Technical Service Bulletin

Topic	55 Insufficient gap width between the tank flap and the side panel
Market area	Nordamerika (4NA),USA+Canada (4UC)
Brand	Audi
Transaction No.	2071697/3
Level	EH
Status	Released for publishing
Release date	Jul 16, 2026

Q8, SQ8, RS Q8

Figure 3. *One of the new water drains.*

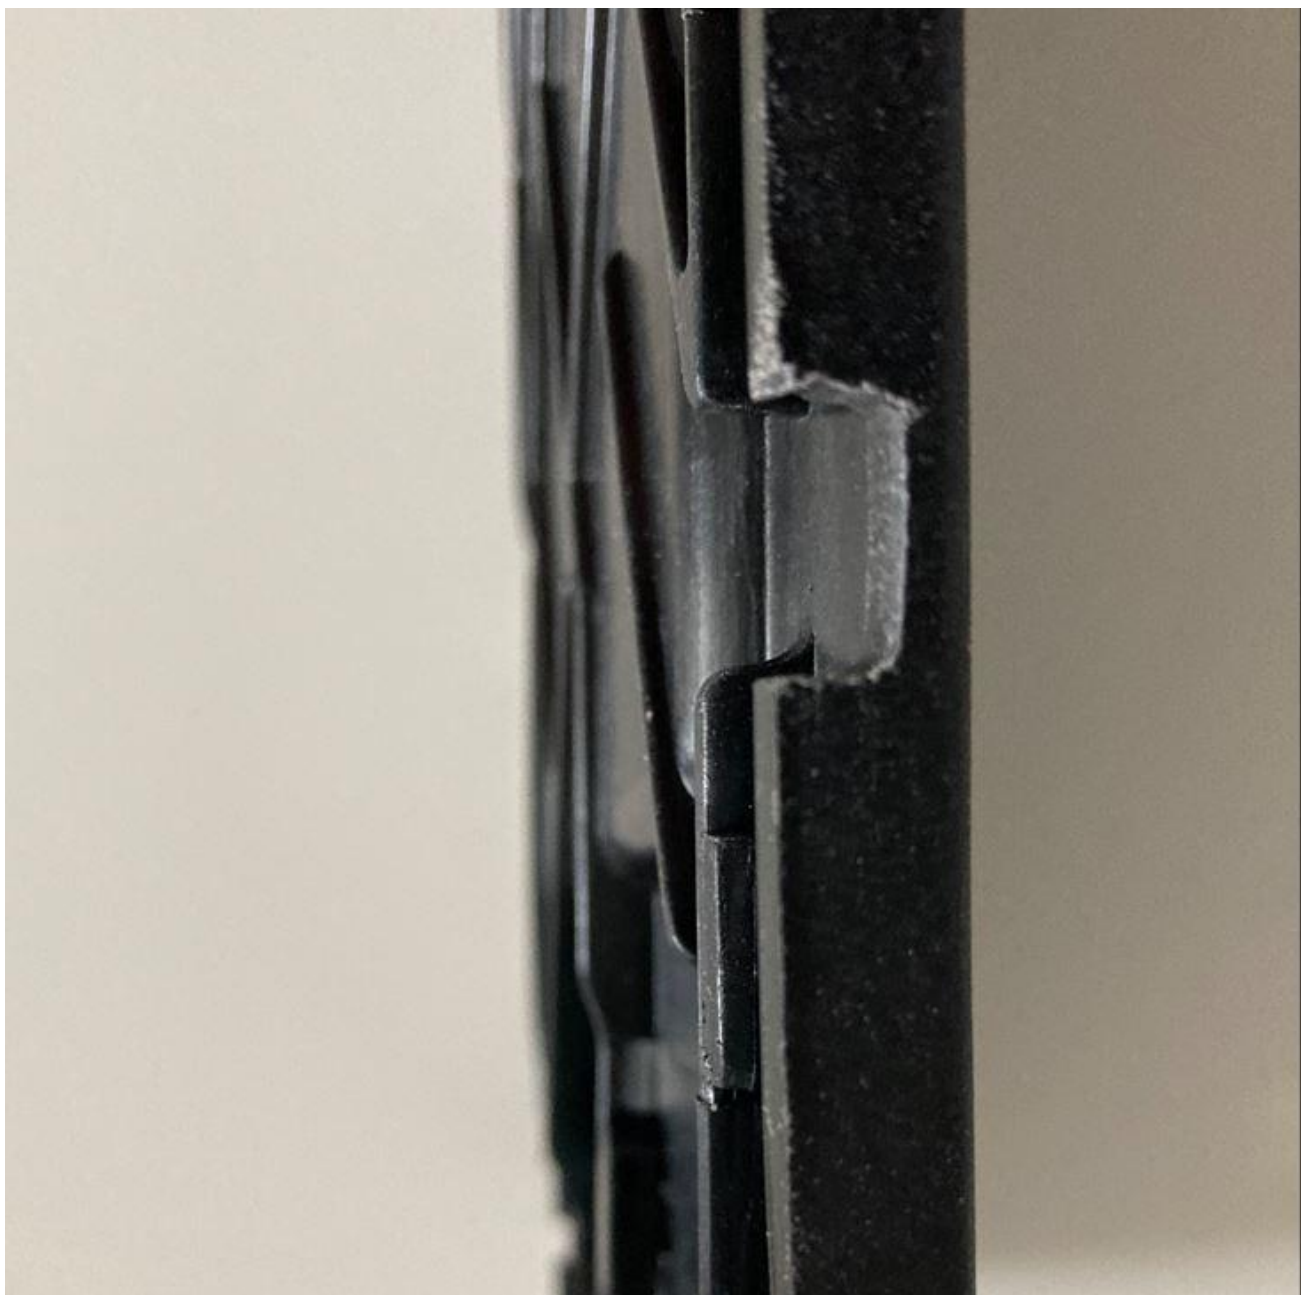
Figure 3 shows the new water drain.
